PLANNING CONSULTATION RESPONSE

Application No	2026/0102
Proposal	Erection of front and side boundary wall 1m to 1.5m in height (Retrospective).
Address	11 Hardwick Grove, Dodworth, Barnsley, S75 3SS
Date of Consultation Reply	16 th March 2026
Consultee	Highways DC

Diagram 2: Footway Visibility at access

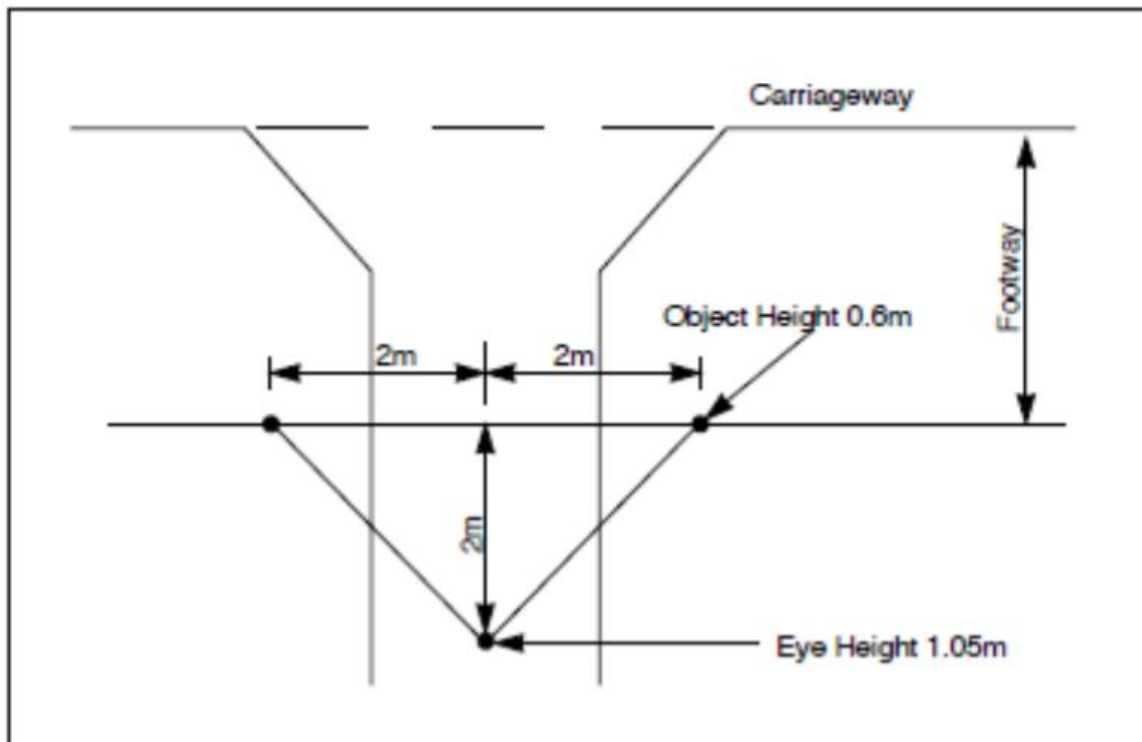
There appear to be discrepancies between the various submitted plans with regard to the position of the wall in relation to the existing driveway. As such, it is unclear whether the required 2m x 2m pedestrian visibility splays are to be provided at the site access. For clarity, the applicant/agent should note that the vehicular access must provide pedestrian visibility splays of 2m x 2m to the back edge of the footway. Nothing shall be erected, retained, planted and/or allowed to grow at or above a height of 0.6m to the rear of the footway which would obstruct the visibility splays; the visibility splays are measured as per the diagram below:
